Plat shall be dimensioned at 24" by 36" leaving a space of a minimum one half inch (½") and a maximum of one and a half inch (1 ½") margin on all four sides of the sheet. WCO 106-1-8(c)(1)

Subdivision Name approved by the county recorder. WCO 106-1-5(a)(1); WCO 106-1-8(c)(1)a; UCA 17-27a-603(1)(a) **Hidden Cove Subdivision has already been used.**

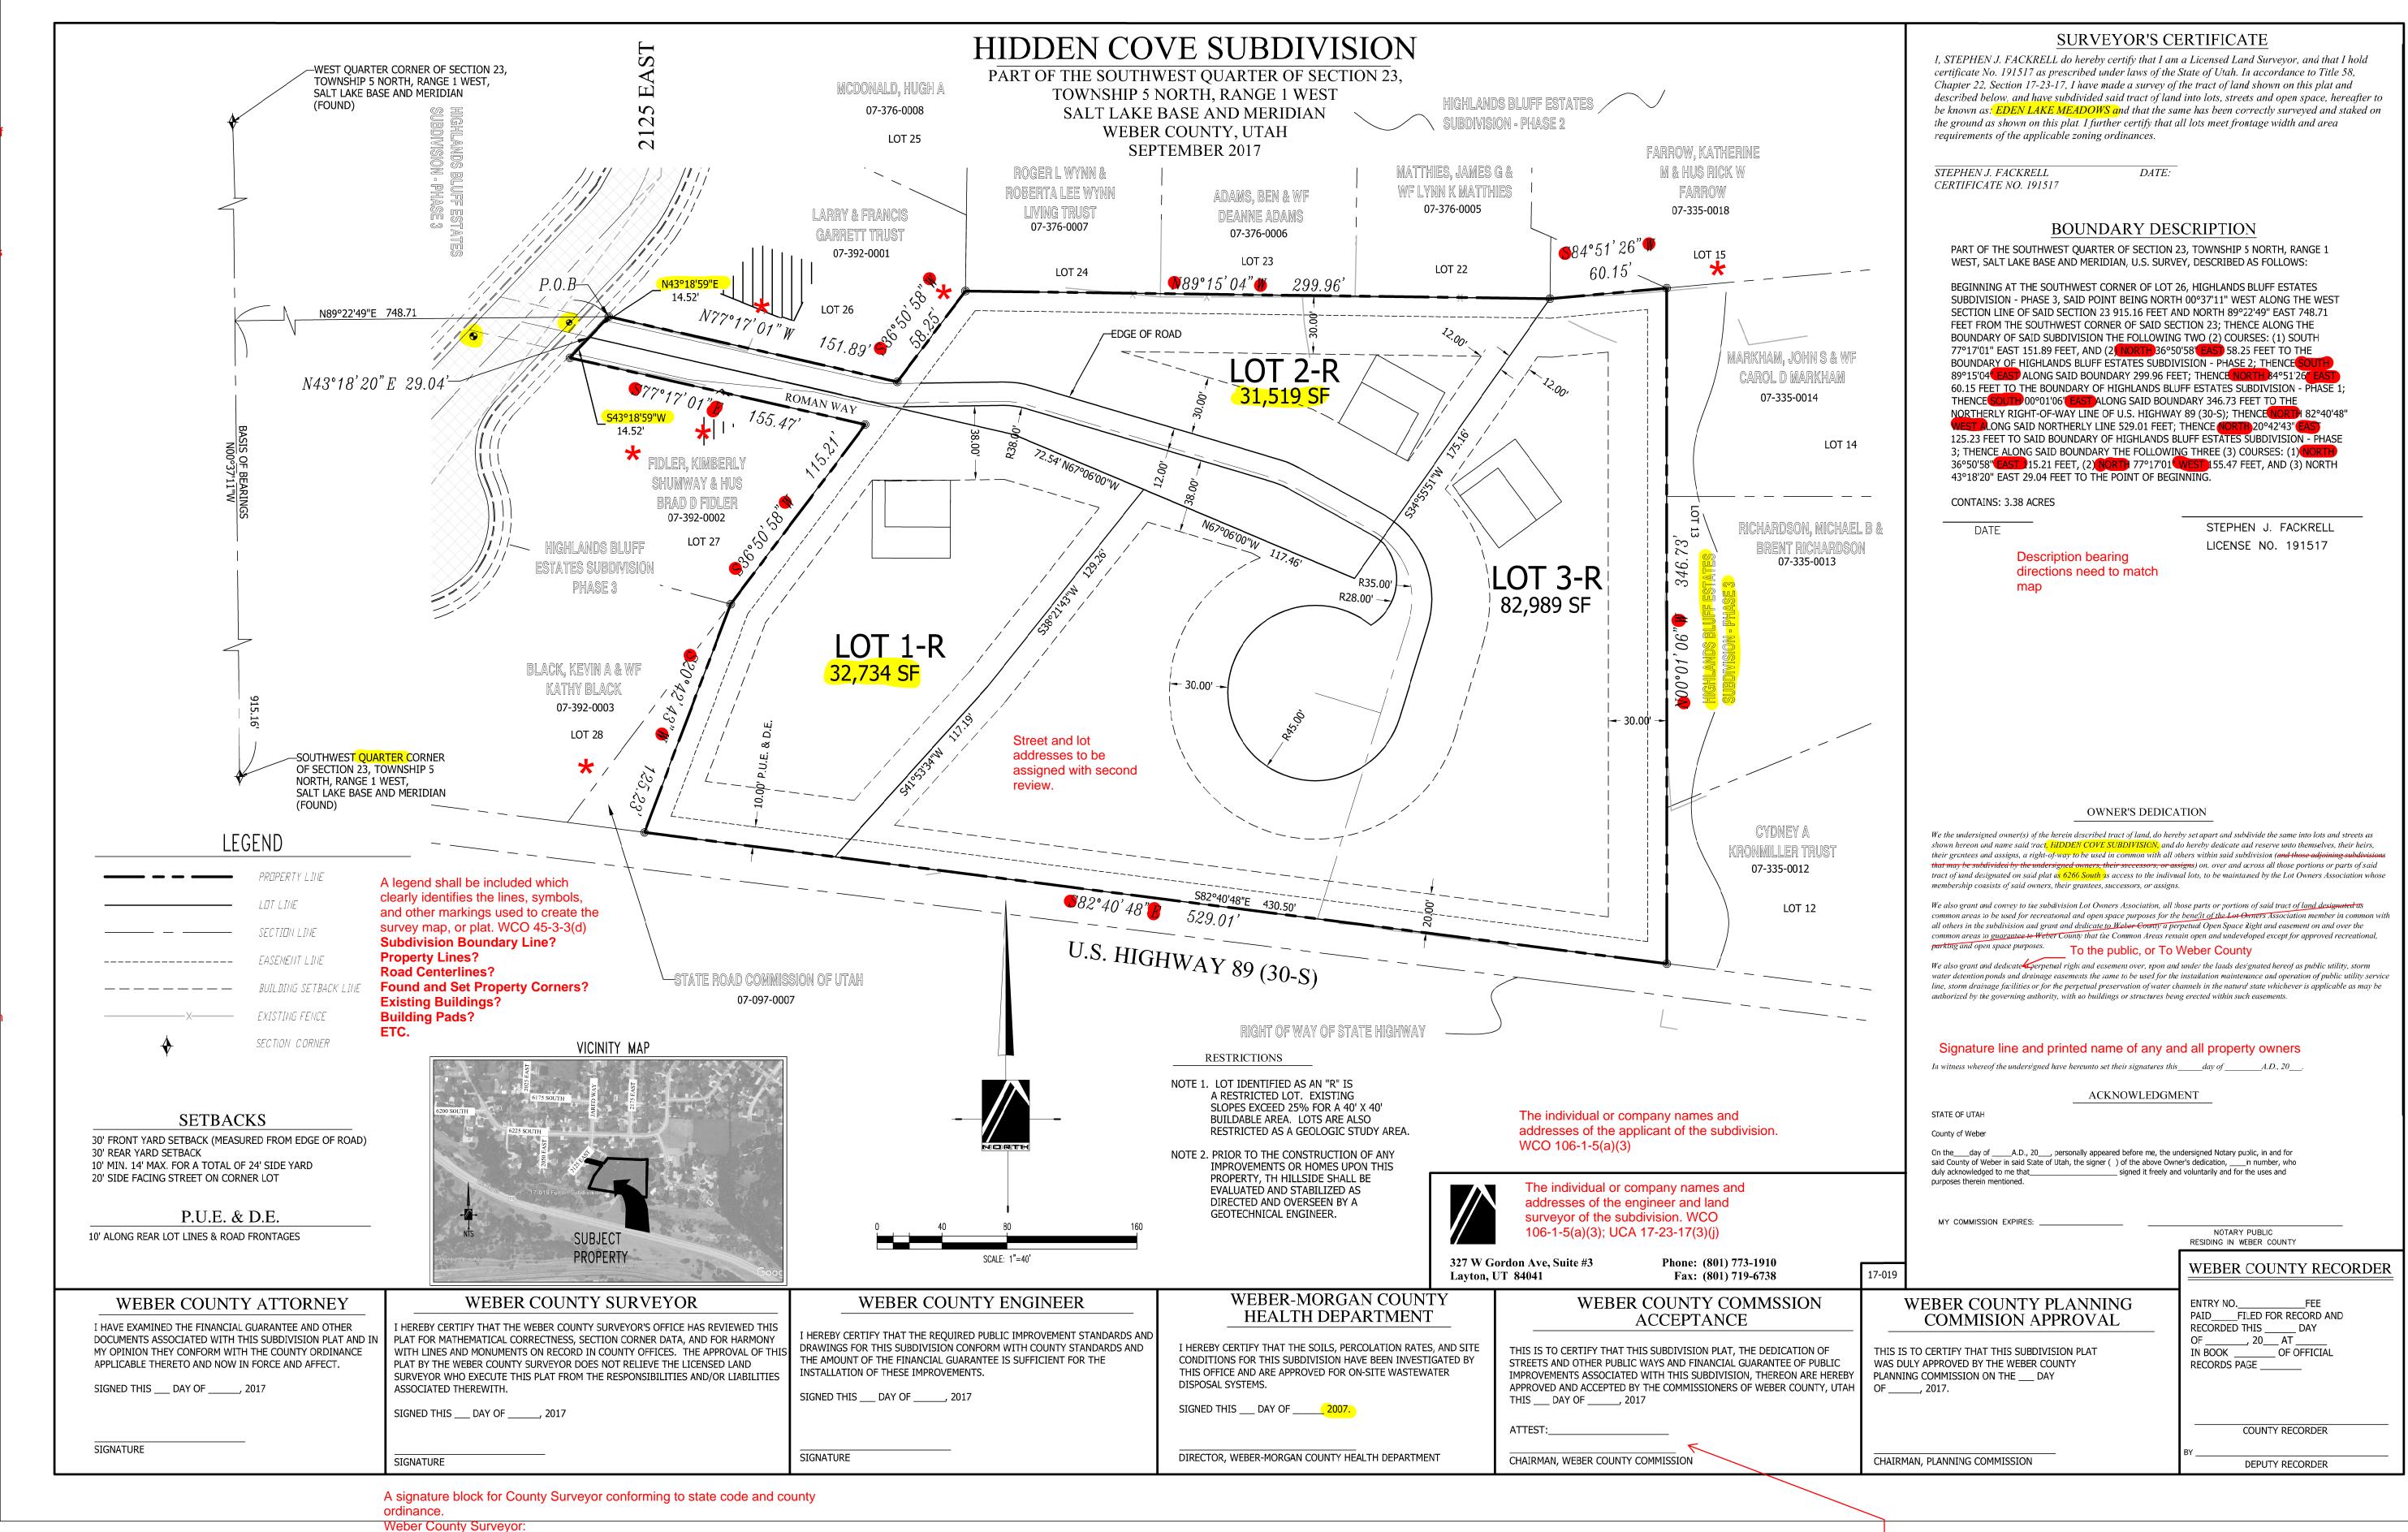
Margins to wide

Missing dimension between Lot 1-R and 2-R

Some text size may print too small.

Building that need to be shown Marked with an

The surveyor making the plat shall certify that the surveyor "holds a license in accordance with Title 58, Chapter 22, Professional Engineers and Professional Land Surveyors Licensing Act". UCA 17-27a-604(4)(b)(i) Wording needs to match

New Signature Block for Weber County Surveyor
